NERC Project 2023-06: CIP-014 Risk Assessment Refinement

July 8, 2025

- Technical Rationale
  - Updated to reflect requirement changes
  - Added a Flowchart

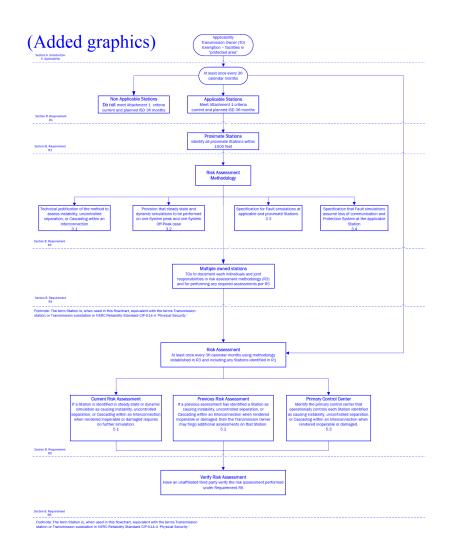
- 2. Transmission Facilities that are operating between 200 kV and 499 kV at a single station or substation, where the station or substation is connected at 200 kV or higher voltages to three or more other Transmission stations or substations and has an "aggregate weighted value" exceeding 3000 according to the table below. The "aggregate weighted value" for a single station or substation is determined by summing the "weight value per line" shown in the table below for each incoming and each outgoing BES Transmission Line that is connected to another Transmission station or substation. For the purpose of this criterion, the collector bus for a generation plant is not considered a Transmission Facility, but is part of the generation interconnection Facility.

Voltage Value of a Line	Weight Value per Line
less than 200 kV (not applicable)	(not applicable)
200 kV to 299 kV	700
300 kV to 499 kV	1300
500 kV and above	<del>0</del> N/A
